Change No. 3
License No. DPR-31

UNITED STATES
ATOMIC ENERGY COMMISSION
WASHINGTON, D.C. 20545

Docket No. 50-250

1.15 INTERIM LIMITS

Figure 3.2-3. Power Spike Factor versus Elevation

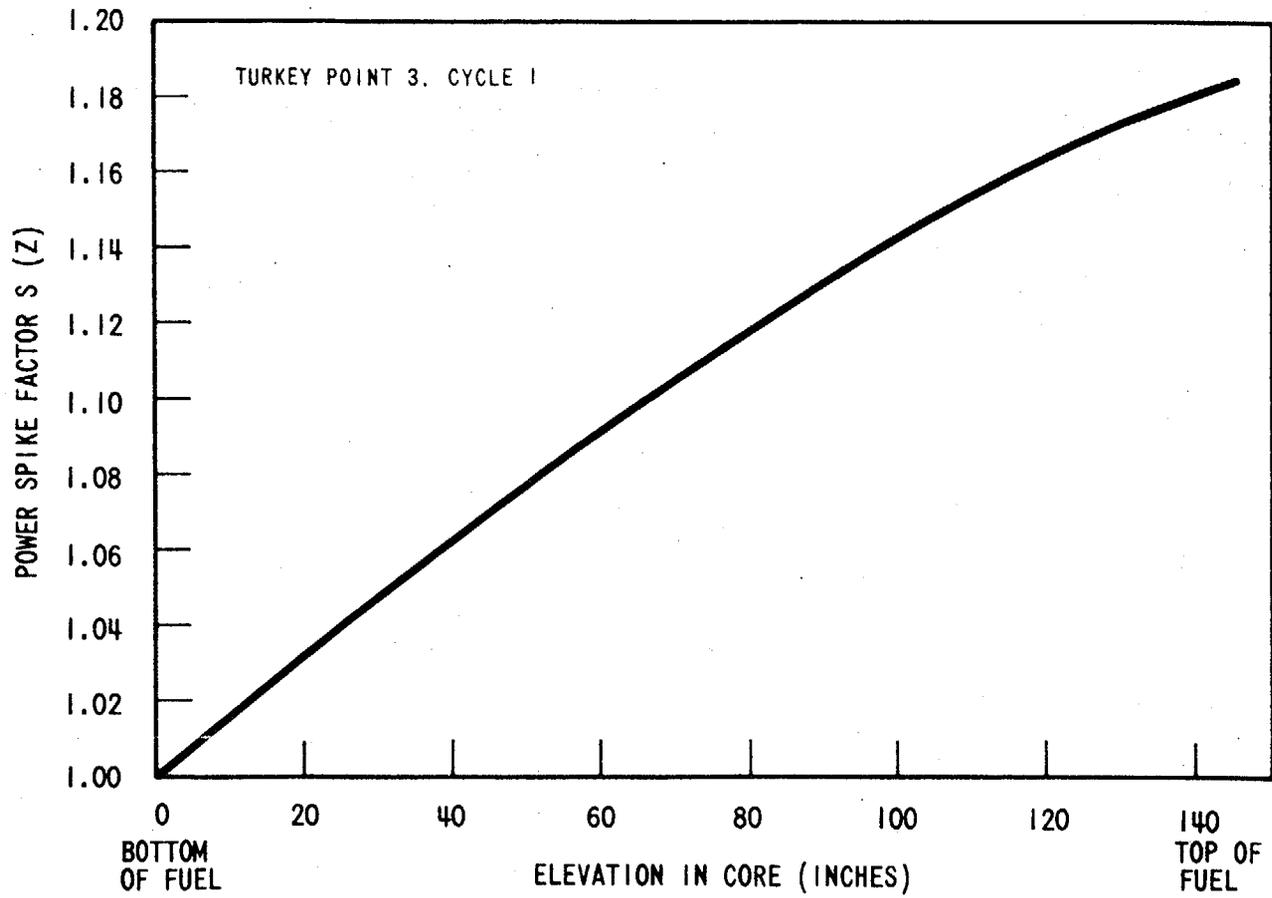
- g. If the L factor used in Section 6.c is 0.95 axial surveillance of F_Z^N shall consist of:
- 1) Two traverses with the movable in-core detectors in appropriate alternate pairs of channels shall be taken every eight hours, or at a frequency of 0, 30, 60, 120, 180, 240, 360 and 480 minutes following accumulated control rod motion of five steps except for control rod exercises limited to within 10 steps from the top of the core. From the traverses, determination that $F_Z^N \leq 1.63/S(Z)$ is the densification penalty factor as a function of core height shown in Fig. 3.2-3. This allows 4% measurement error.

The measured value of F_q^N must be additionally corrected by including a penalty as shown on Figure 3.2-3 (at the appropriate core location) to account for fuel densification effects before comparison with the limiting value above.
